# WURLITZER SERVICE SLANTS

**SUBJECT:** All -1 3500, 3510 and 3560 Series Phonographs shipped from the factory prior to the following Serial Numbers:

**PROCEDURE:** To change Junction Box wiring, perform the following:

**FIGURE 1**

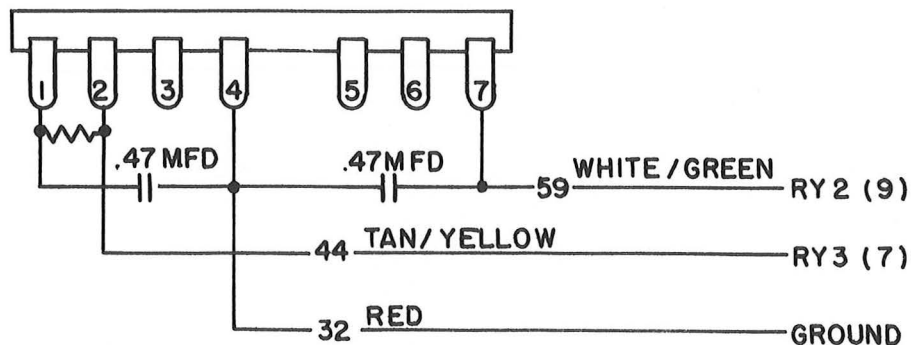
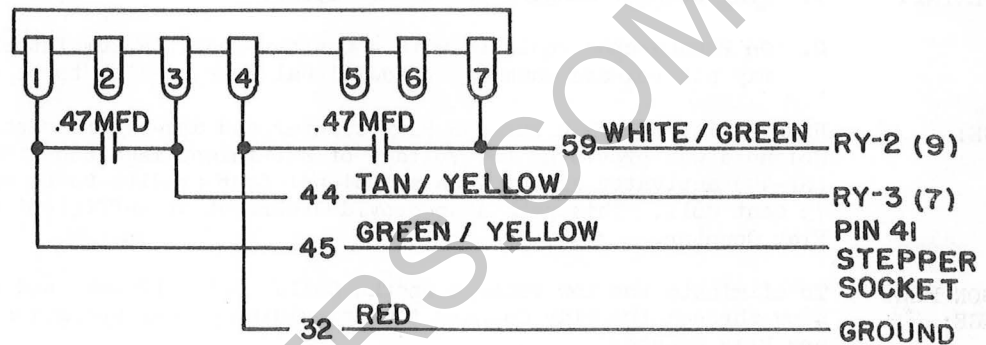
1. Play Counter hanging up on half cycle.
2. On Phonographs equipped with 4 Quarter Credit Accumulator, Dollar Relay (RY-44) may not release causing an additional four credits to be established on Playrak.

**CAUSE:** High resistance path through Play Counter and arc-suppression circuit for Cancel Solenoid was providing low voltage of sufficient magnitude to keep Dollar Relay (RY-44) activated allowing an additional four credits to be established through the 75 Cent Coil. This path also provided current of sufficient magnitude to hang up Play Counter.

**REASON FOR CHANGE:** To eliminate the low voltage on the Dollar Relay (RY-44) and the erroneous current flow through the Play Counter thus providing proper operation of Credit Accumulator and Play Counter.

1. Unsolder and remove the 27 ohm Resistor located between terminals 1 and 2 as shown in Figure 1. Discard Resistor.

2. Unsolder and remove the Tan/Yellow wire from terminal 2, shown in Figure 1, and connect this wire to terminal 3 as shown in Figure 2. Do not solder at this time.
3. Remove lead of .47 mfd. Capacitor connected between terminals 1 and 4, as shown in Figure 1, from terminal 4. A Red Wire and another .47 mfd. Capacitor are also connected to this terminal. Do not remove these.
4. Connect lead of .47 mfd. Capacitor, removed in Step 3, to terminal 3, as shown in Figure 2. Solder capacitor lead and Tan/Yellow wire.
5. Connect a suitable length of 22 A.W.G. wire, Green/Yellow, between .47 mfd. Capacitor (terminal 1) and Pin 41 of Stepper Socket as shown in Figure 2. Solder both connections.

This wiring change places the .47 mfd. Capacitor directly across the Cancel Solenoid circuit (44-45).
